**Re: Pensacola Hydroelectric Project, FERC Project No. 1494-438  
Response to Comments on Updated Study Report**

RESPONSE TO COMMENTS  
ON  
UPDATED STUDY REPORT

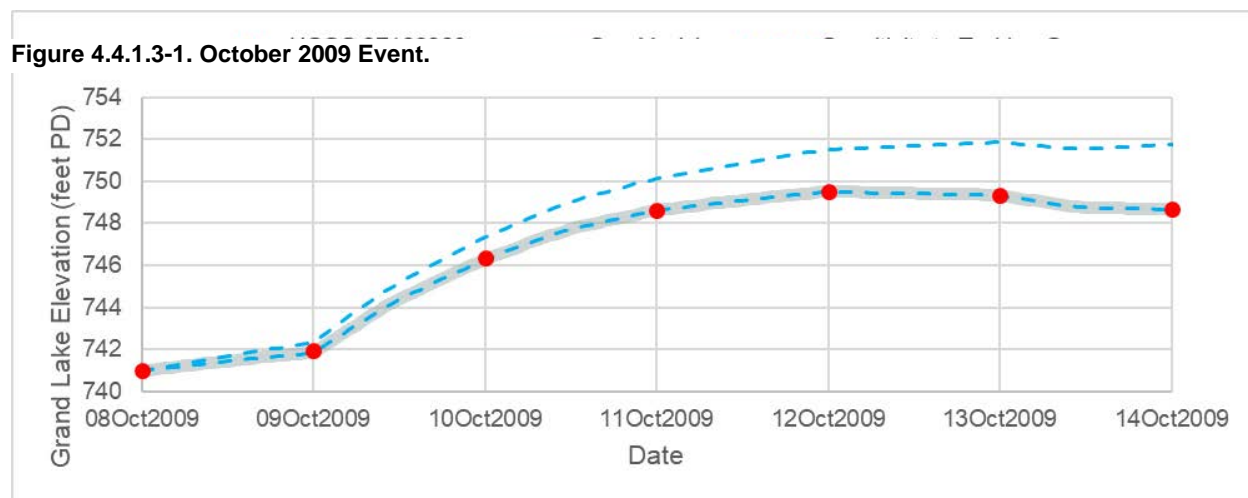
It appears that this method could pre-determine validation by: (a) back-calculating inflow based on historic outflow and change in storage (elevation); (b) calculating outflow and change in storage based on the inflow; and (c) comparing the resulting water surface elevation to historic gage data. Please confirm or clarify this interpretation of the methodology, using sample calculations. Also, please explain why the reservoir elevations from normal simulations of the inflow events used for other aspects of the study could not be (or were not) compared directly to the historic gage data.<sup>262</sup>

GRDA clarifies that its method did not pre-determine validation. While the reservoir inflow and spillway gate openings were calculated from the historical record, the hydropower discharge was modeled according to the same operating rules as other simulations. Therefore, validation was not pre-determined. Rather, the modeled hydropower operations, an important component of the OM, were validated. Secondly, the validation results simply (though indirectly) demonstrate the volume conservation of the calculations.

An example of the model's sensitivity to the modeled hydropower discharge is shown in Figure 4.4.1.3-1 below for the October 2009 event. Sample calculations were requested, and although the full chain of calculations cannot be reasonably included outside of a spreadsheet, some sample elevations and volume

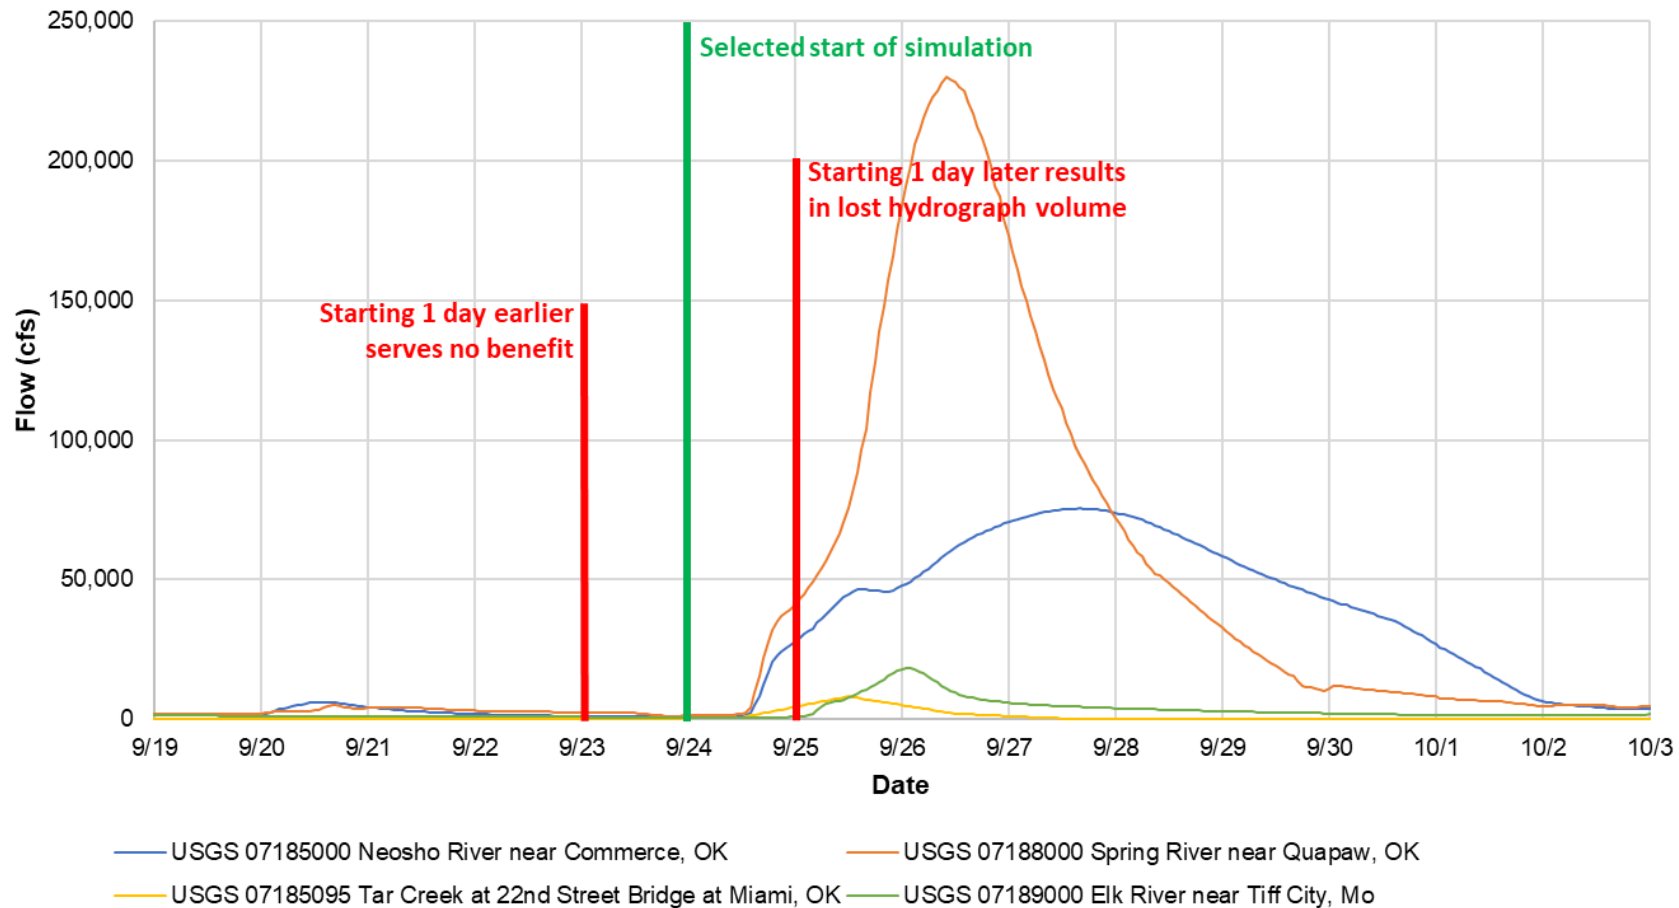
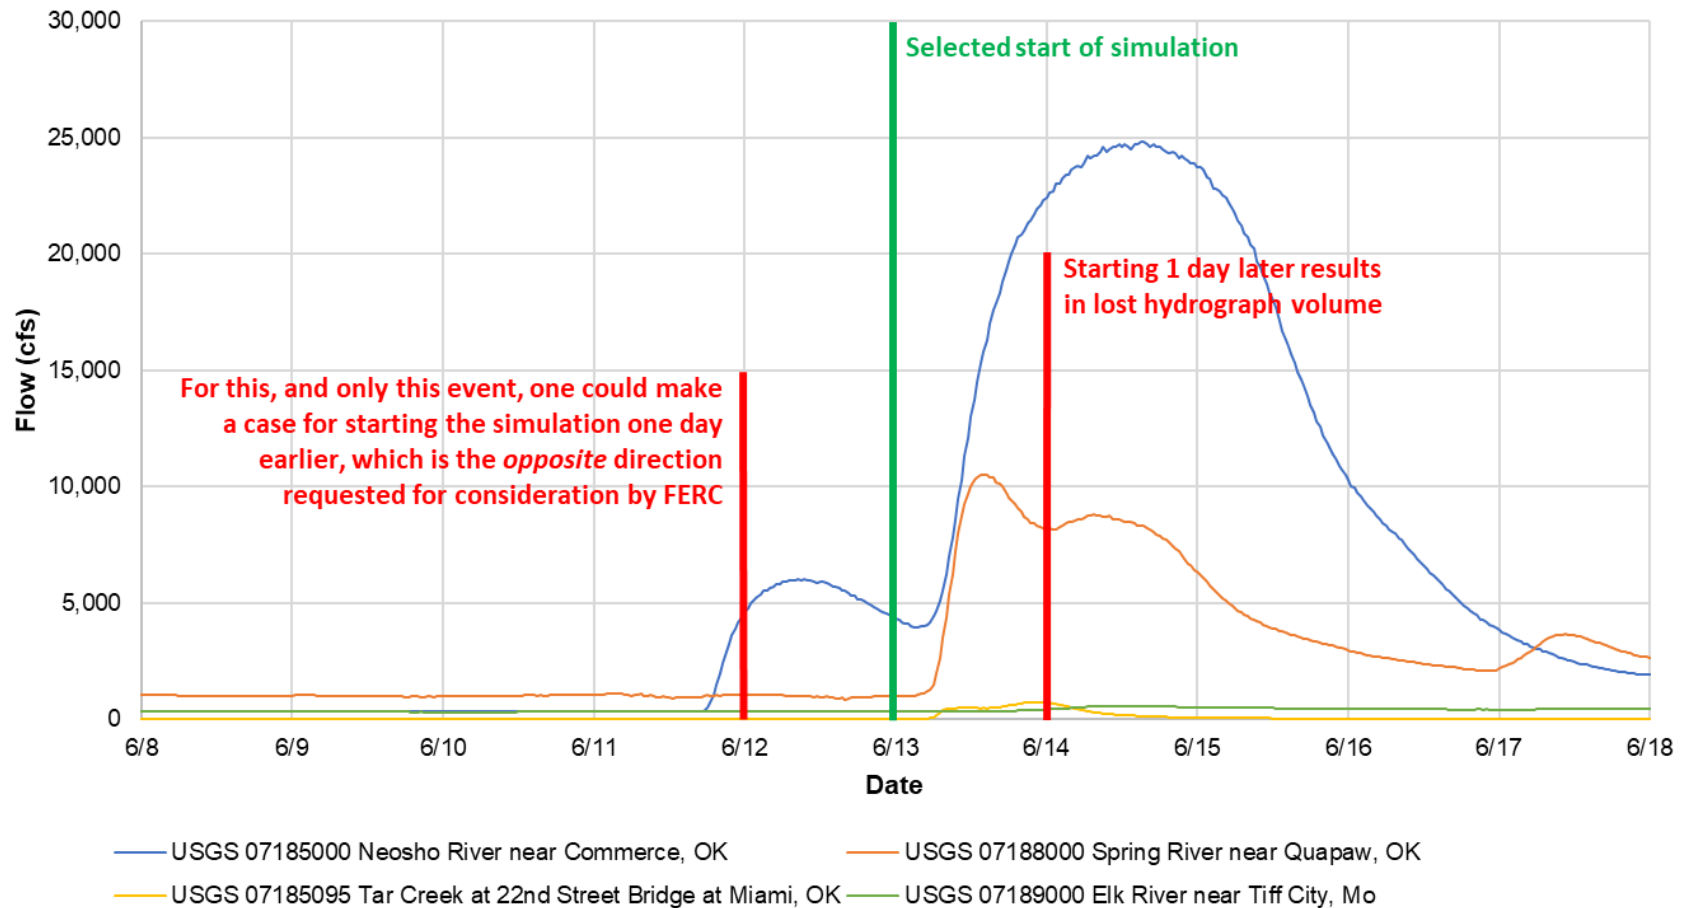
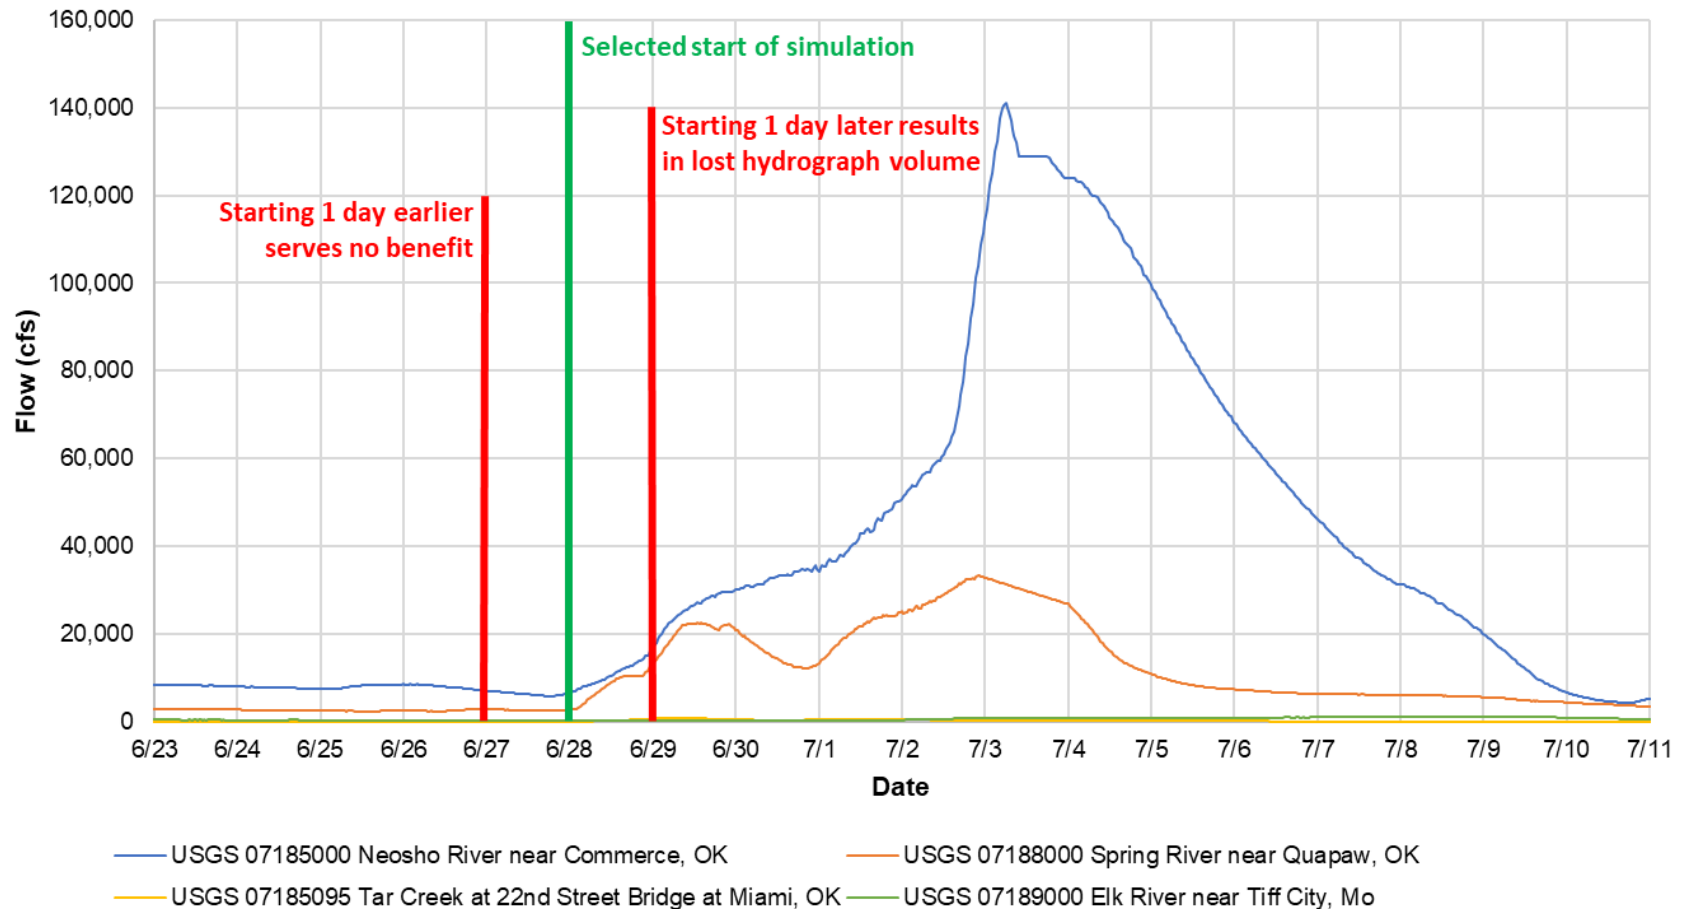
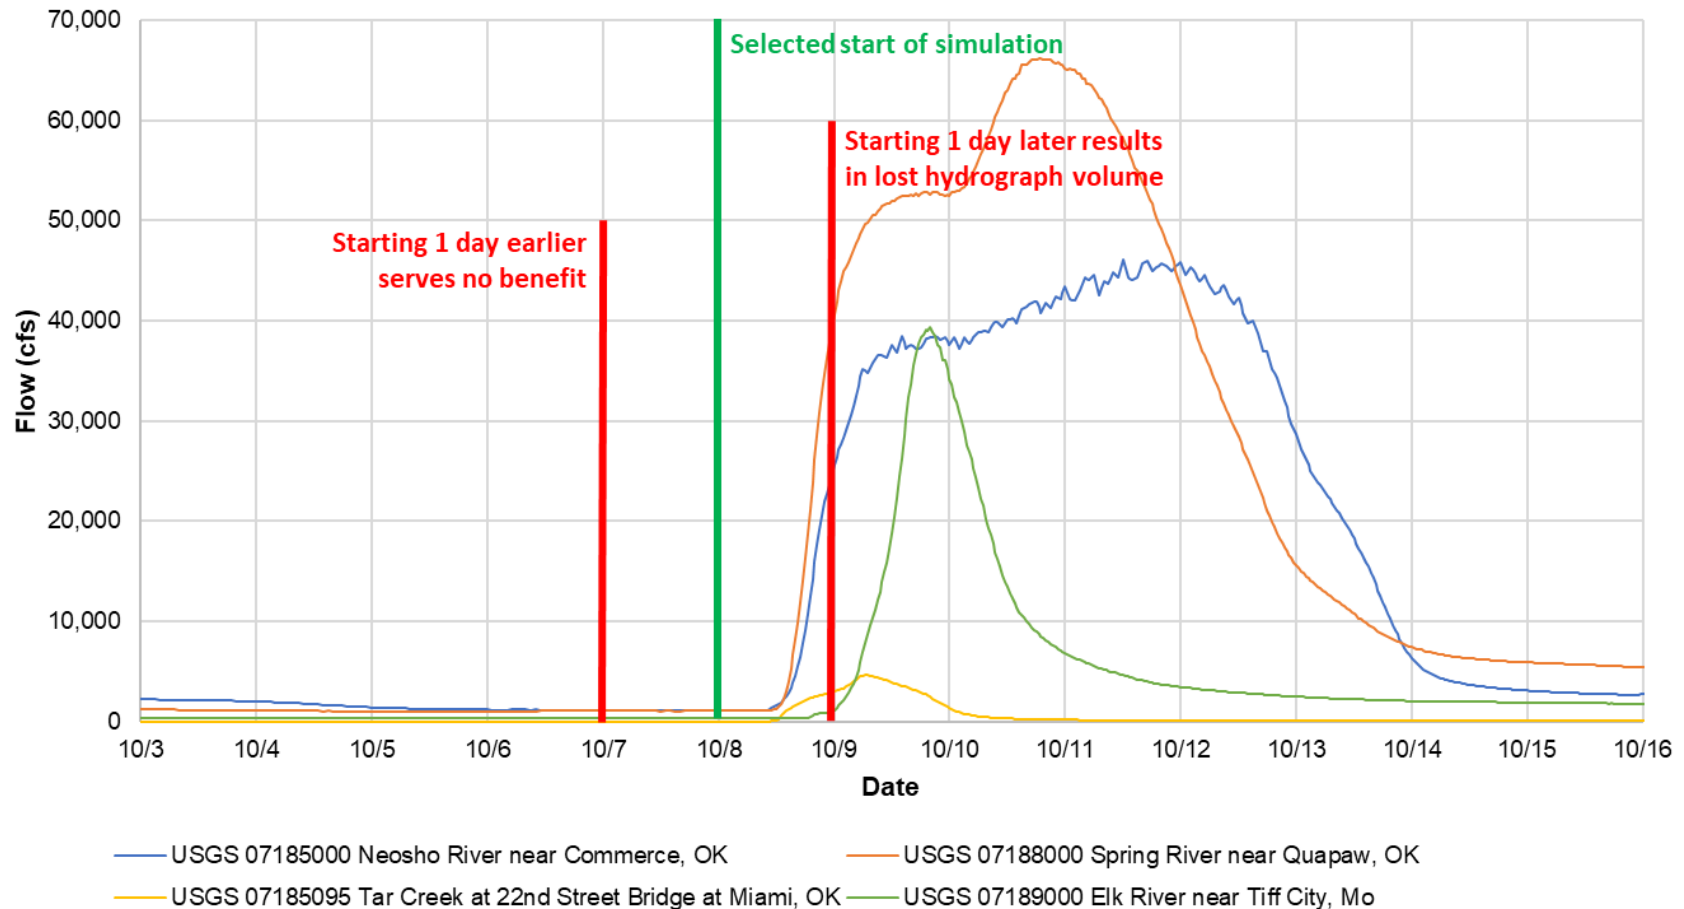
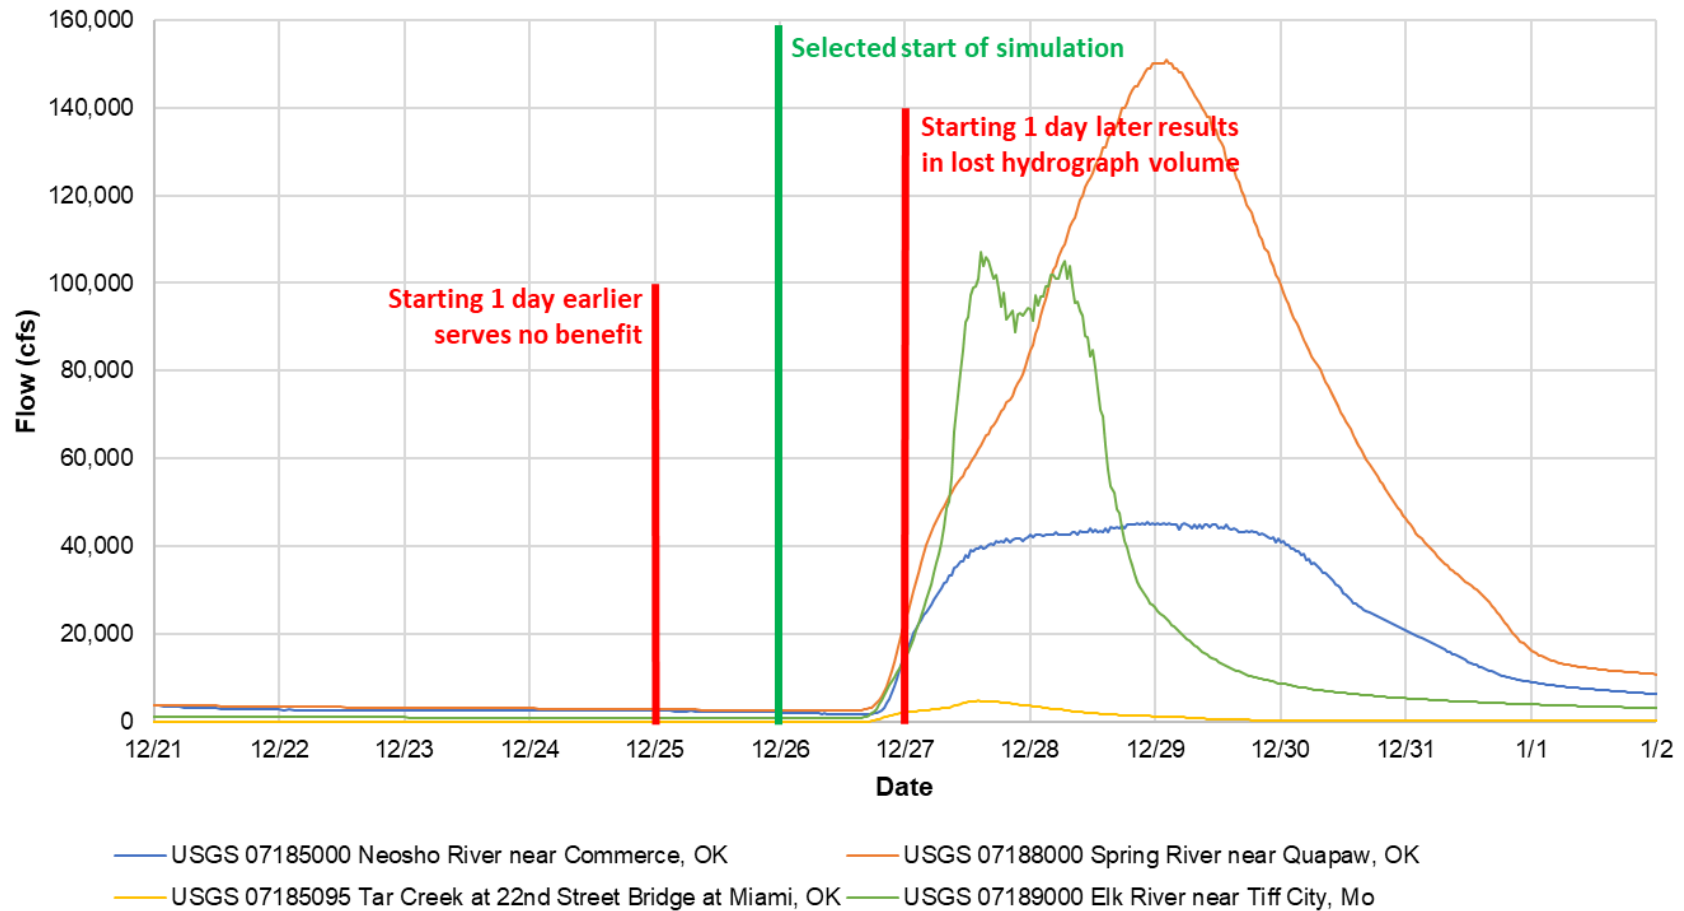
whether the hydrographs (figures C.7-C.12) are converging toward the reservoir rule curve that was in place at the time of the event, and, if so, whether this convergence is related to the stage matching discussed in section 5.4.3, *Flood Routing Model Stage Matching*. Further, please clarify whether this constraint also applies for the 100-year inflow event, which has no specified date from which to derive a rule curve elevation. Finally, please explain whether the start of the simulations could be adjusted so that the prescribed starting elevation for a given inflow event is still in effect when the storm flows arrive.<sup>269</sup>

Note that the simulations themselves extend past the last date displayed in the figures. The purpose of the figures is to show the start date of the simulation, the inflow event hydrographs, and how GRDA selected the most appropriate starting date.
